APPLICATION FOR ERECTION OF NEW TENEMENT HOUSE.

PLOT PLAN
 SCALE: THIRTY TWO FEET EQUALS ONE INCH
 APARTMENT HOUSE FOR VINCENT ASTOR E.S.O.
 305-317 WEST 45TH STREET N.E. 100 FEET WEST OF EIGHTH AVE.
 TRACY AND SMARTWOOD ARCHITECTS
 244 FIFTH AVE. NEW YORK

Amendment to Plans and Application No. 48 N. B. 1914.

Location 305-317 West 45th Street.

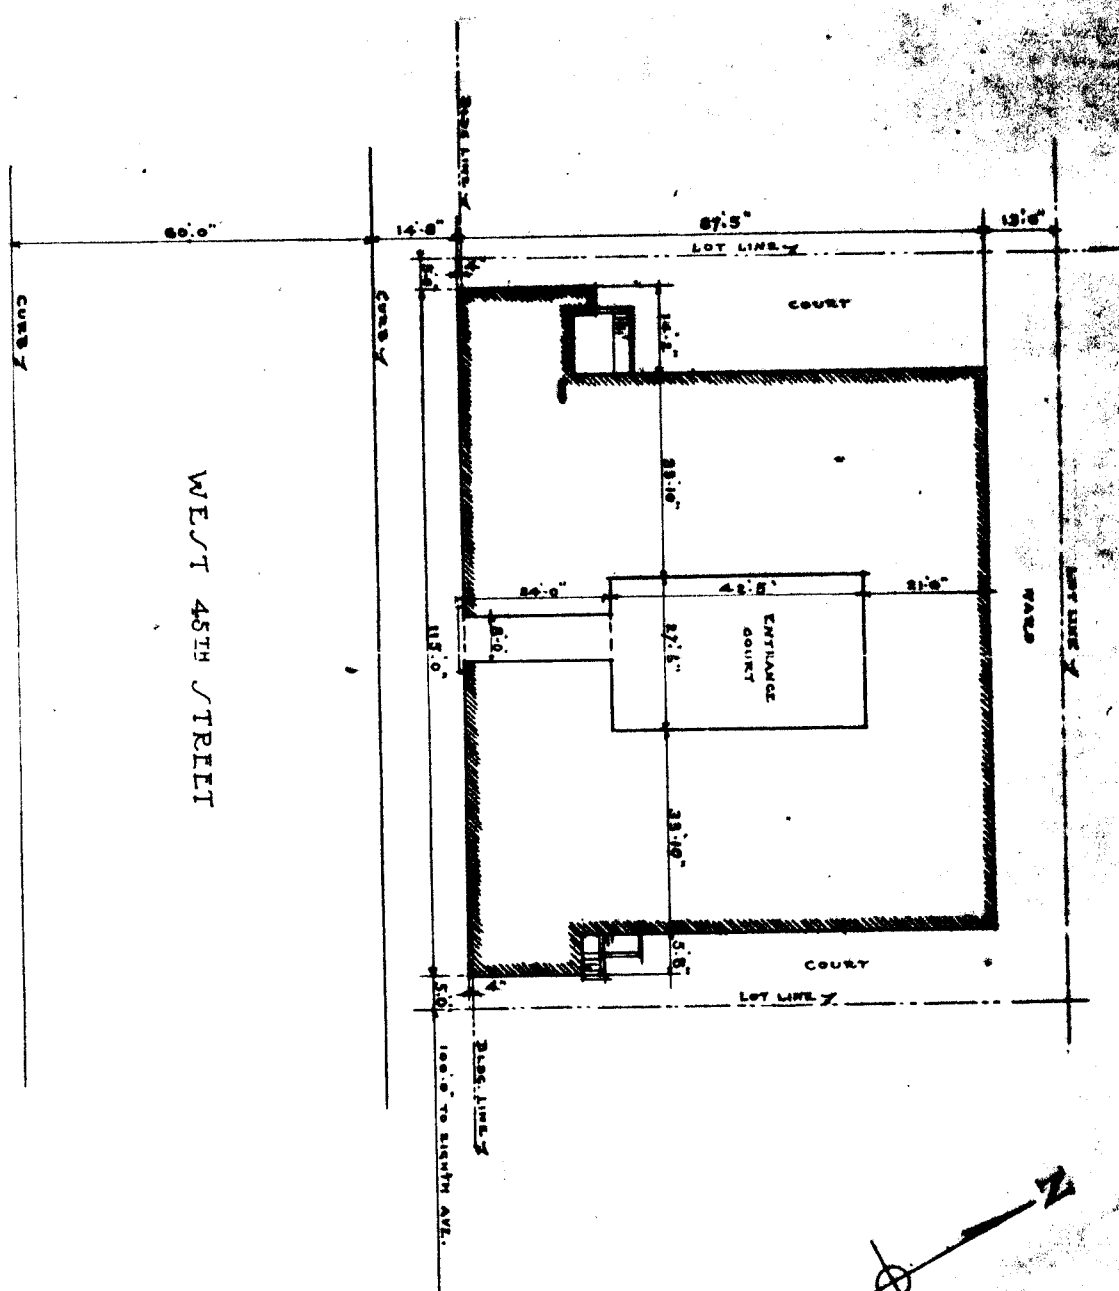
45. Will any of the walls, partitions or ceilings throughout building be covered, sheathed or wainscoted wholly or in part? (Section 37.) *No. Fair lights where noted 6/3/14 J.S.*

46. Will transoms or partition sash to private halls or to adjoining room for thorough ventilation be provided? (Section 63.) *No. Fair lights where noted 6/3/14 J.S.*
